ATTACHMENT 3

M170117

Responses to the NRC RAIs for the Model No. 2000 Transportation Package

Figure 7.2-1: Stress State at the Standard Lifting Ear / Mounting Plate Interface

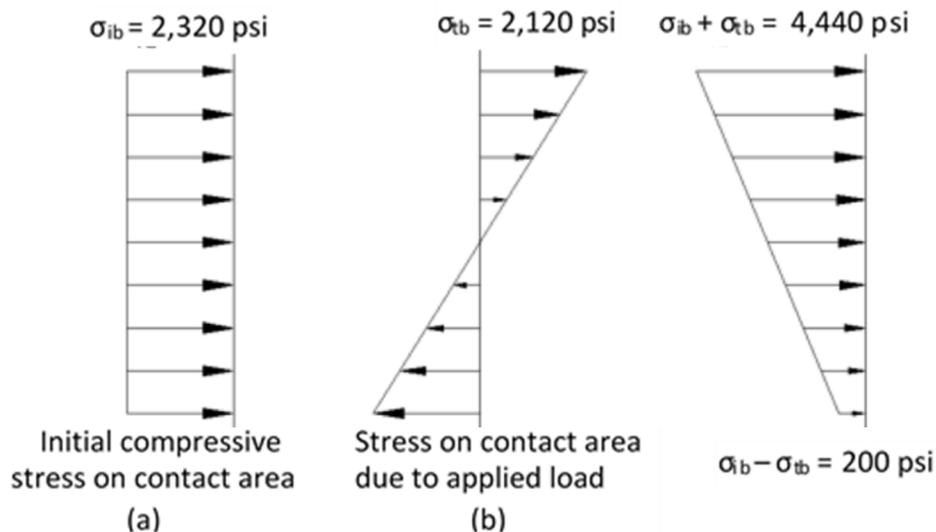
7.2 Identify appropriate torque ranges for the Section 7 torque values.

The Section 7 torque values are exact numbers which implies the package cannot be safely transported if torque values above and below these values are employed. Package user personnel will also have difficulty applying such exact torque values. Therefore, the applicant should specify a range of torque values to clarify what is the acceptable package configuration and to facilitate package assembly.

The stress state at the standard lifting ear mounting plate interface for minimum preload is illustrated in Figure 7.2-1.

The results of the previous lifting ear bolt load and stress evaluation support the lifting ear bolted joint design for the Model 2000 transport container plus high performance insert (HPI) with a decay heat of 1500 W and the revised bolt torque of 600 ± 20 ft-lb.
